Section 12A Application No. Y/I-DB/2
To Amend Discovery Bay Outline Zoning Plan
For rezoning the permissible use from staff quarters to flats
At Area 6f, Discovery Bay

Response to Comments
October 2016

**Section 12A Application No.Y/I-DB/2
For rezoning the permissible use from staff quarters to flats at Area 6f, Discovery Bay
Response to Comments**

Section 12A Application No.Y/I-DB/2 for rezoning the permissible use from staff quarters to flats at Area 6f
 Applicant's response to the departmental comments made available by District Planning Office on 25 and 28 July 2016

FIGURE 6-1

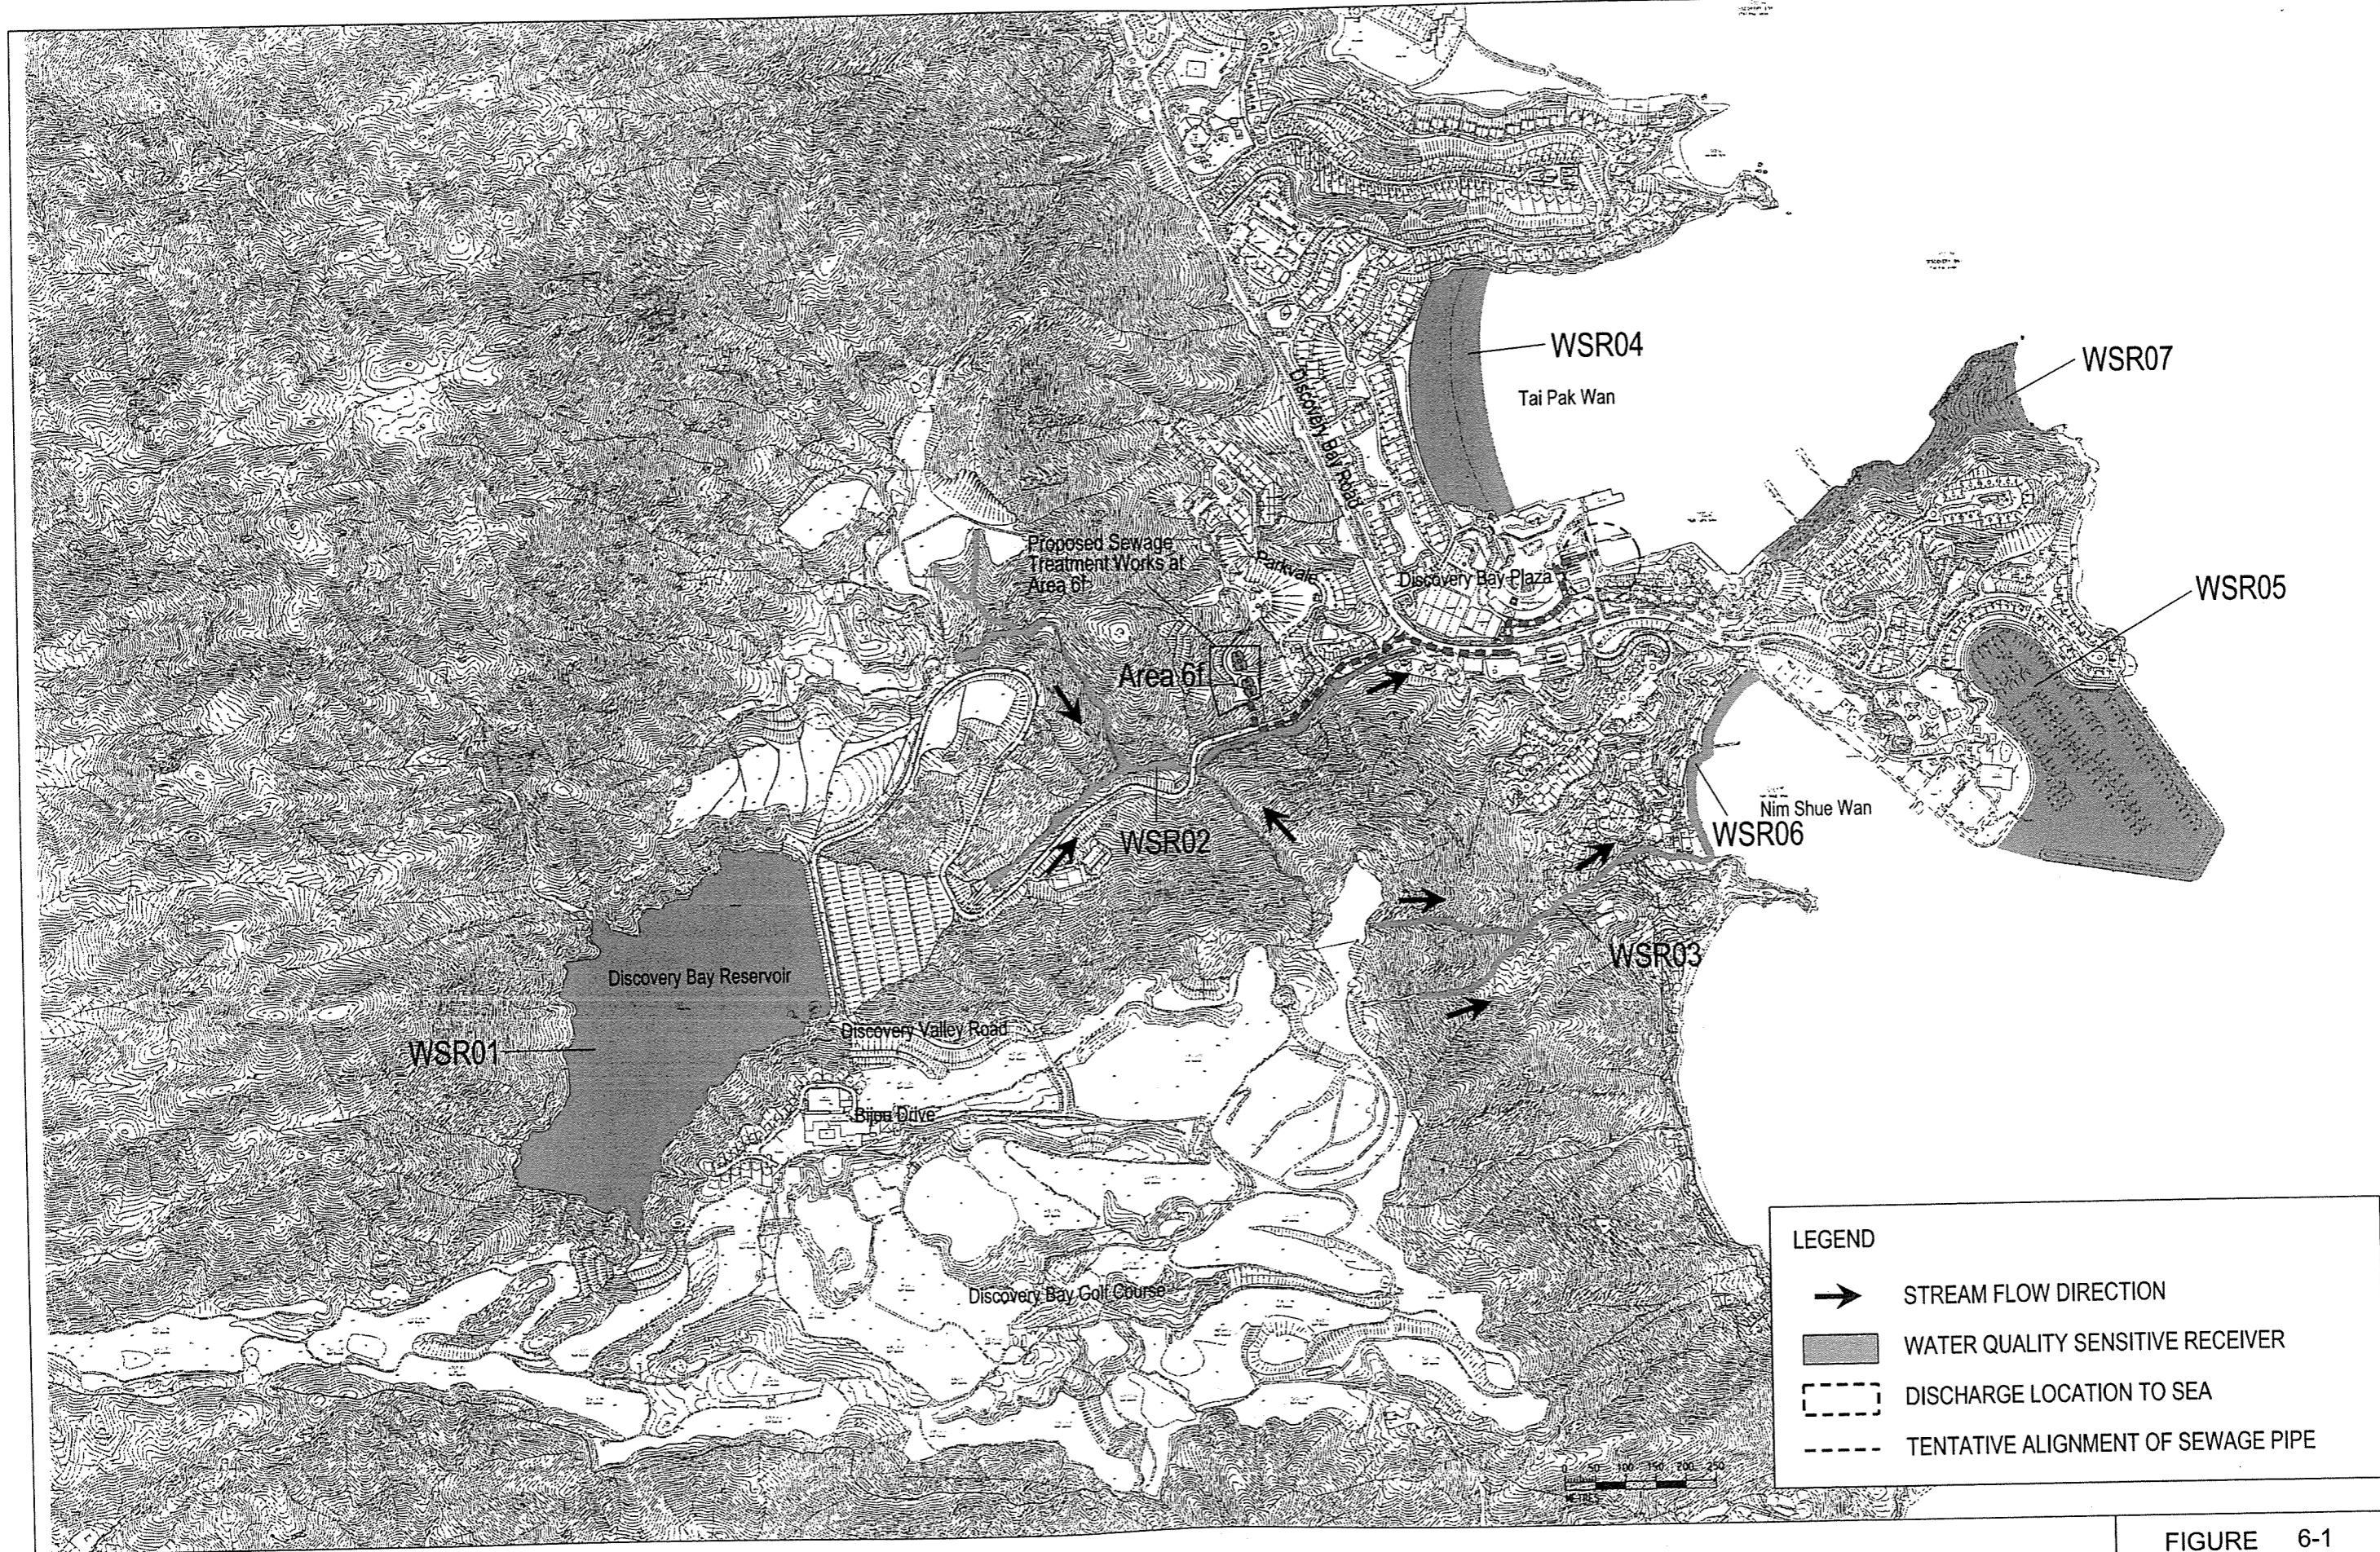
<p>8. <u>S6.3.1.2</u> Please indicate the discharge location to the nullah and the neighbouring marine waters in relevant figure.</p>	<p>The sewage generated by Area 6f is now proposed to be discharged via gravity sewage pipe then to marine waters near Discovery Bay Plaza. The tentative pipe alignment and discharge location have been indicated in Figure 6.1.</p> <p>Moreover, the current tentative alignment for the gravity sewage pipe has considered the worst case scenario especially during dry seasons. During the subsequent detailed design, it is recommended to conduct further analysis to establish any base flow along the spillway and hence the feasibility of discharging the treated effluent into the nullah and box culvert directly.</p>
<p>9. <u>S2.1.1.4 and S8.1.2.1</u> Please add "A discharge license will be obtained under the WPCO prior to discharge".</p>	<p>Noted. The statement has been added to Section 2.1.1.4 and 8.1.2.1.</p>
